Informal Document No. 2 (2001)
2 February 2001

Administrative Committee for the TIR Convention, 1975
(Thirtieth session, 22 and 23 February 2001,
agenda item 6 (b))

AMENDMENT PROPOSALS TO THE TIR CONVENTION, 1975

**AMENDMENT PROPOSALS TO THE TIR CONVENTION, 1975
(Phase II of the TIR revision process)**

"Sketch No. 10

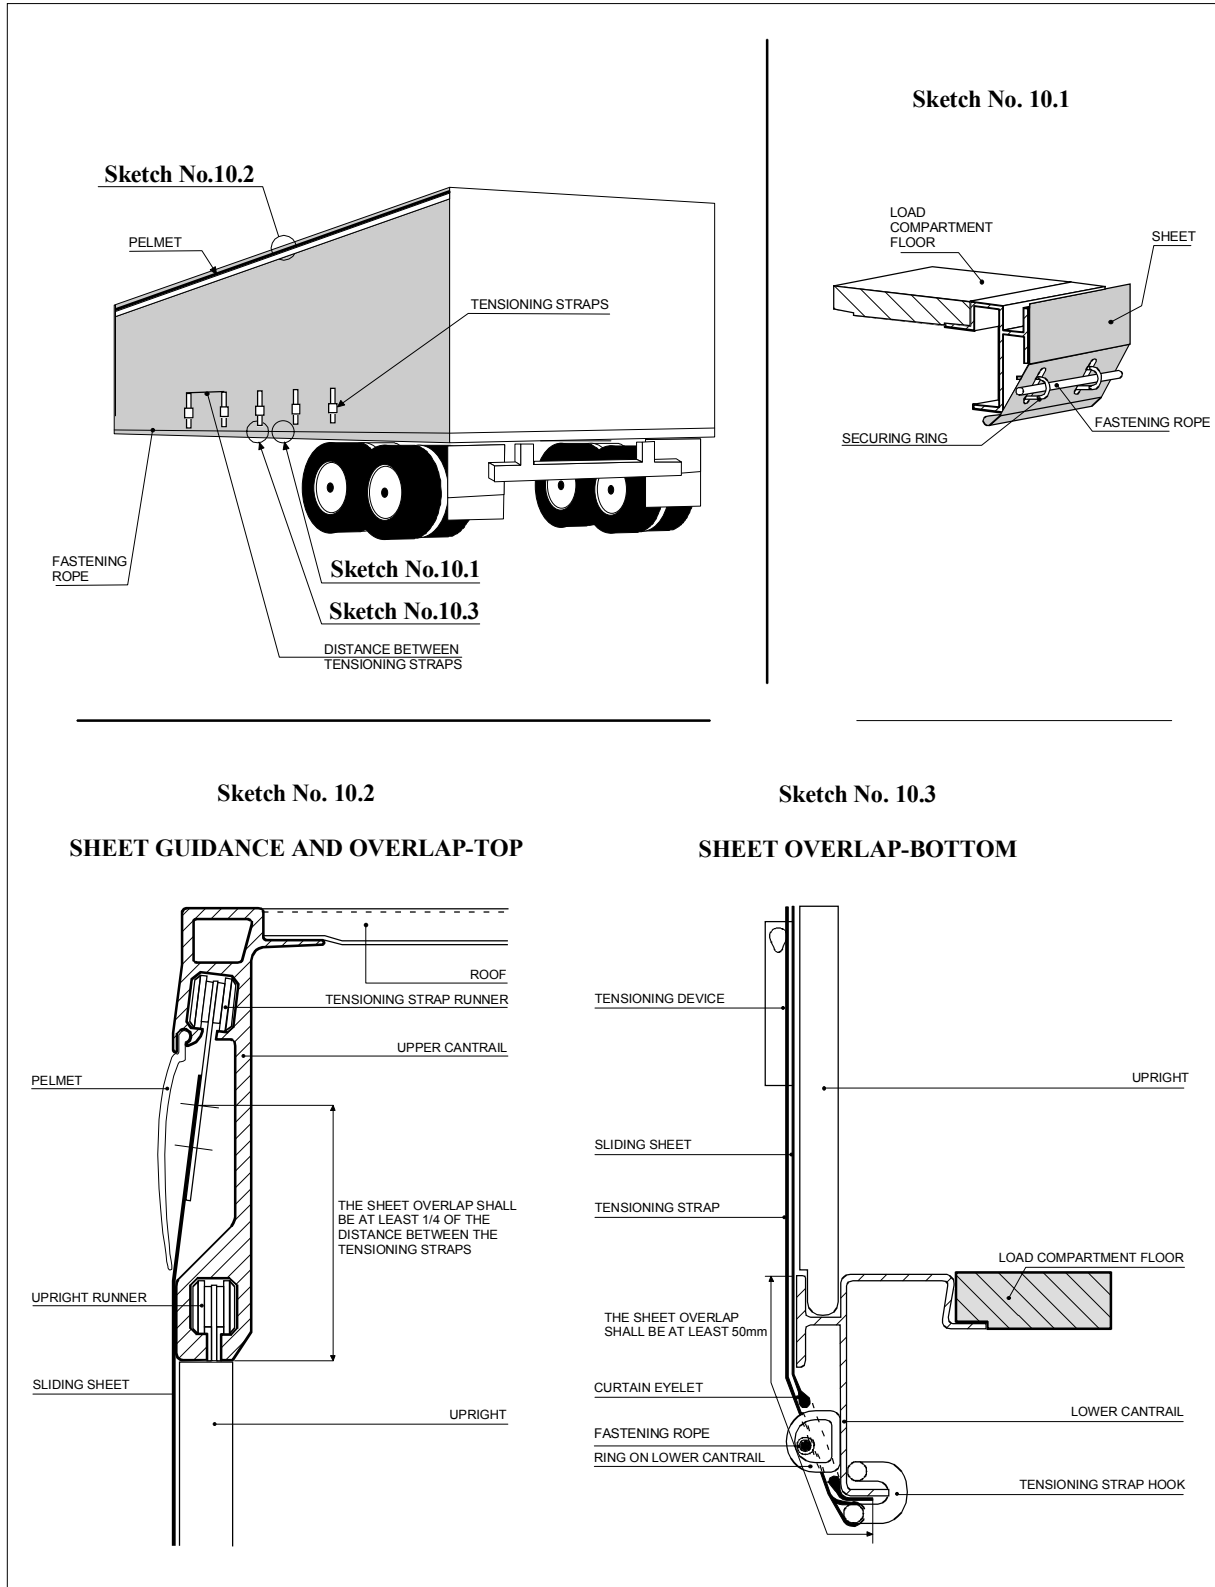
1. Where applicable, the provisions of Articles 1, 2 and 3 of these Regulations shall apply to vehicles with sliding sheets. In addition, these vehicles shall conform to the provisions of this Article.

2. Notwithstanding the provisions of paragraph 3 of this Article, the sliding sheets, floor, doors and all other constituent parts of the load compartment shall fulfil either the requirements in Article 3, paragraphs 6, 8, 9 and 11 of these Regulations or the requirements set out in (i) to (vi) below.

- (i) The sliding sheets, floor, doors and all other constituent parts of the load compartment shall be assembled in such a way that they cannot be opened or closed without leaving obvious traces.

- (ii) The sheet shall overlap the solid parts at the top of the vehicle by at least 1/4 of the actual distance between the tensioning straps. The sheet shall overlap the solid parts at the bottom of the vehicle by at least 50 mm. The horizontal opening between the sheet and the solid parts of the load compartment may not exceed 10 mm measured perpendicular to the longitudinal axis of the vehicle at any place when the load compartment is secured and sealed for Customs purposes.

- (iii) The sliding sheet guidance and other movable parts shall be assembled in such a way that closed and Customs sealed doors and other movable parts cannot be opened or closed from the outside without leaving obvious traces. The sliding sheet guidance and other movable parts shall be assembled in such a way that it is impossible to gain access to the load compartment without leaving obvious traces. The system is described in sketch No. 10 appended to these Regulations.

- (iv) The horizontal distance between the rings, used for Customs purposes, on the solid parts of the vehicle shall not exceed 200 mm. The space may, however, be greater but shall not exceed 300 mm between the rings on either side of the upright if the construction of the vehicle and the sheets is such as preventing all access to the load compartment. In any case, the conditions laid down in (ii) above shall be complied with.

- (v) The distance between the tensioning straps shall not exceed 600 mm.
 - (vi) The fastenings used to secure the sheets to the solid parts of the vehicle shall fulfil the requirements in Article 3, paragraph 9 of these Regulations.”

Add the following new sketch to the existing sketches appended to Annex 2:
